To: SPI-4 working group 01-149r0  
From: SDV working group via Bill Ham  
Date: May 01, 2001  
Subject: Specific changes to SPI-4 recommended by SDV

This document contains the recommendations of the SDV working group for changes to SPI-4 rev 04.

Figure 1 - Device to device driver-receiver connections

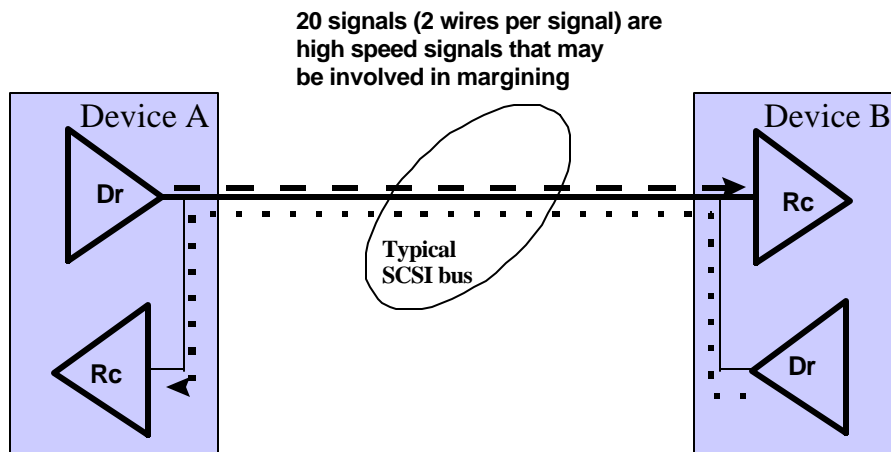
## 1. Change 1

Add the definition for a "driver-receiver connection" to section 18.1.4 of SPI-4.

Figure 1 shows a portion of a single SCSI bus segment between two SCSI devices or simple expanders illustrating the driver receiver connections that may be affected by signal margining. Each device has a Driver, Dr, and a Receiver, Rc, for each signal. For purposes of signal margining all signal drivers and receivers within the same SCSI device or simple expander use the same control information obtained from a mode page or ECP. No means is provided for controlling individual signals in the SCSI device or simple expander. There may be other SCSI devices, simple expanders, or terminators not shown in Figure 1 that are connected to the path between the driver and the receiver. Two driver receiver connections exist between any two SCSI devices or simple expanders, one for each direction.
